1  +-----+
2  |                8802-3/802.3 REVISION REQUEST                |
3  +-----+
4  DATE: 27/01/2016
5  NAME: Lennart Yseboodt
6  COMPANY/AFFILIATION: Philips / Philips
7  E-MAIL: lennart.yseboodt@philips.com
8
9  REQUESTED REVISION:
10 STANDARD: 802.3-2015
11 CLAUSE NUMBER: 33
12 CLAUSE TITLE: Data Terminal Equipment (DTE) Power via Media
13                Dependent Interface (MDI)
14
15 PROPOSED REVISION TEXT:
16
17 This MR pertains to Figure 33-16, page 657, the PD state machine.
18 Change the entry arc condition into IDLE to read:
19 (Vpd < Vreset) * mdi_power_required * !pd_reset
20
21 RATIONALE FOR REVISION:
22
23 The entry arc into IDLE reads "[ (Vpd < Vreset) + !power_received ] *
24 mdi_power_required * !pd_reset"
25 The effect is that at ANY voltage below Vport_pd min, this condition
26 will apply and reset the state machine to IDLE.
27 The intent is to allow a global override to reset the SM to IDLE

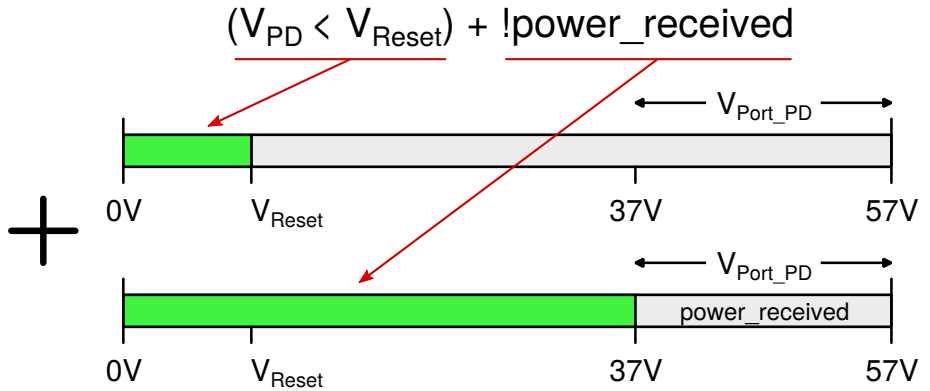
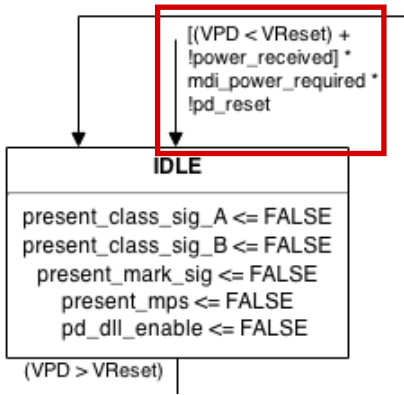
28 when the PI voltage drops below Vreset, but this has been
29 done incorrectly.
30 See comment #213 against D1.5 for P802.3bt
31
32 IMPACT ON EXISTING NETWORKS:
33
34 None.
35
36
37 +-----+
38 |Please attach supporting material, if any                       |
39 |Submit to:-   David Law, Chair IEEE 802.3                     |
40 |and copy:-    Adam Healey, Vice-Chair IEEE 802.3             |
41 |                                                      |
42 |At:-          E-Mail: stds-802-3-maint-req@ieee.org          |
43 |                                                      |
44 |                +----- For official 802.3 use -----+    |
45 |                | REV REQ NUMBER: 1294                      |    |
46 |                | DATE RECEIVED: 27th January 2016         |    |
47 |                | EDITORIAL/TECHNICAL                      |    |
48 |                | ACCEPTED/DENIED                          |    |

Any open arrow (an arrow with no source block) represents a global transition. Global transitions are evaluated continuously whenever any state is evaluating its exit conditions. When a global transition becomes true, it supersedes all other transitions, including UCT, returning control to the block pointed to by the open arrow.

In other words: unless a PD is powered, the SM will continuously flip back to the IDLE state. This entry arrow into IDLE has existed since 802.3at
